**Re: EnviroSAFE Services of Ohio, Inc.  
Oregon, Lucas County, Ohio  
EPA Identification Number: OHD 045 243 706; Ohio Permit Number: 03-48-0092  
CMS Work Plan NOD Response**

**Responses to Ohio EPA May 27, 2011 Comments on  
Envirosafe Services of Ohio, Inc.'s Corrective Measures Study**

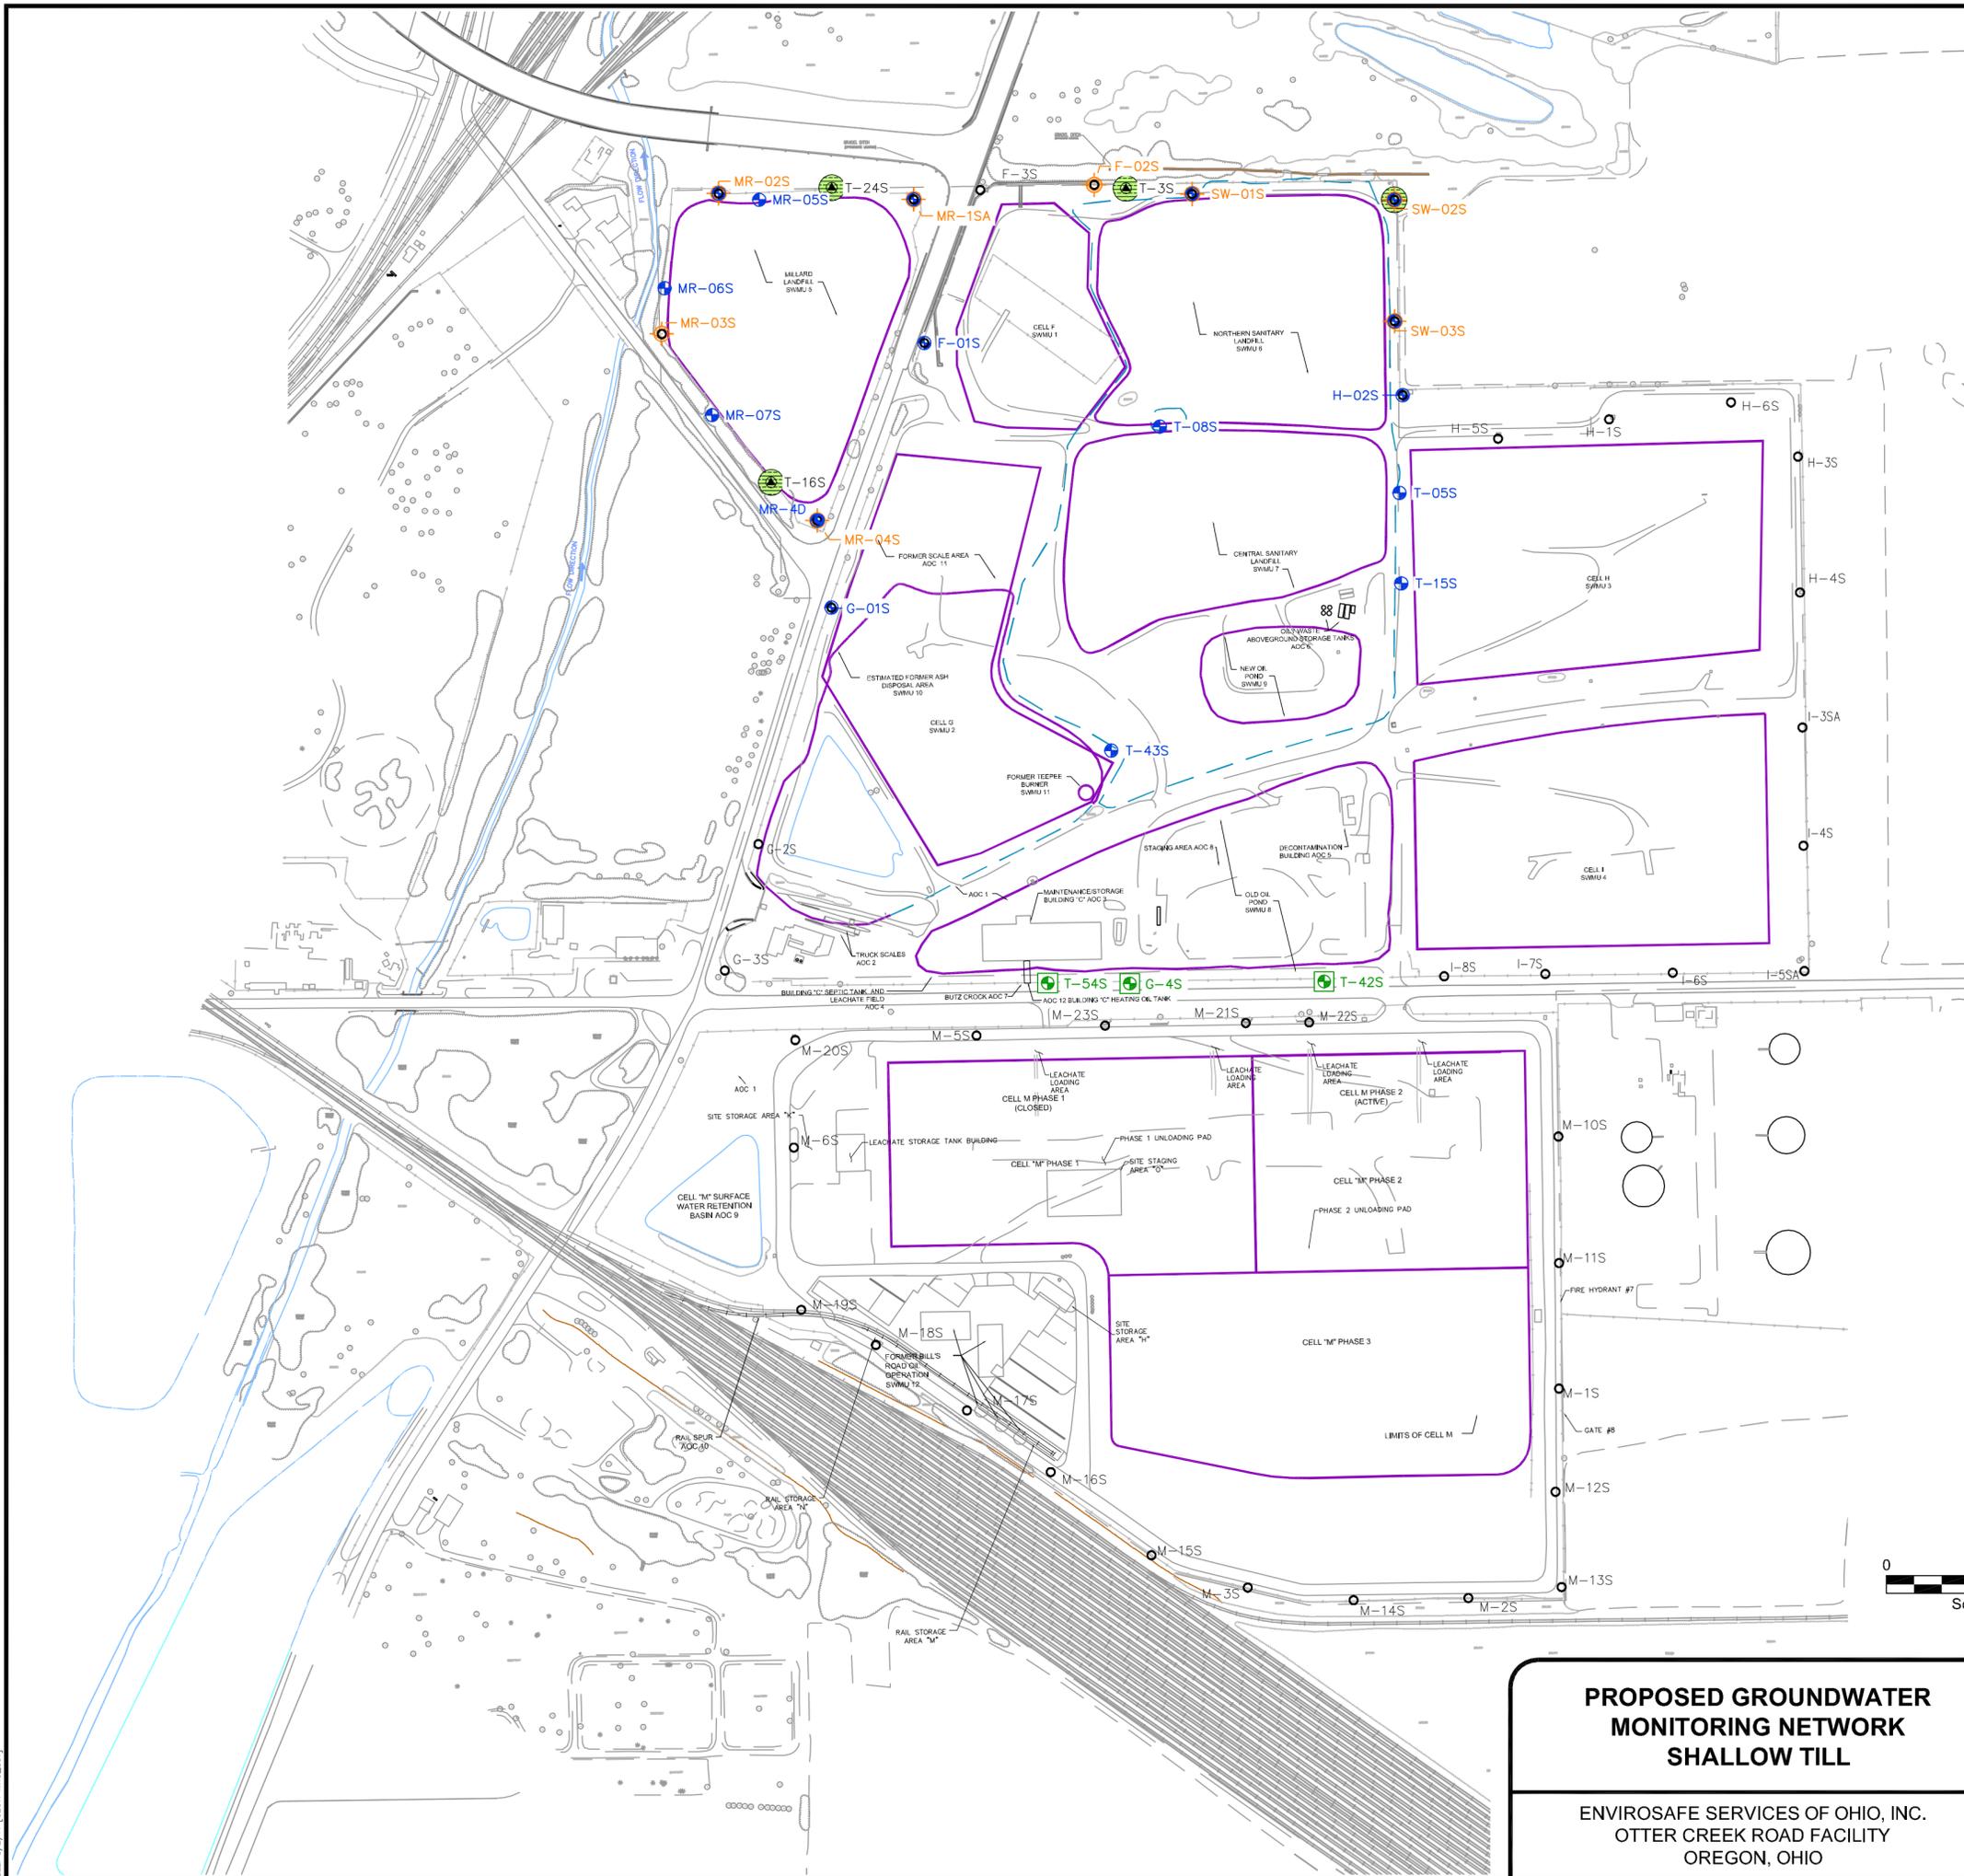
39. Section 9.2.1, Page 90, Paragraph 3. As discussed on April 26, 2011, ESOI will revise this section to include monitoring well F-2S as an affected well located next to SWMU 1.

- **Monitoring well F-2S is included as an Affected Well, as shown on Figure 5c. Section 9.2.1 has been revised to include F-2S as one of the four Affected Wells in the shallow till associated with SWMU 6 since F-2S is located at the northwest corner of SWMU 6 and northeast corner of SWMU 1.**
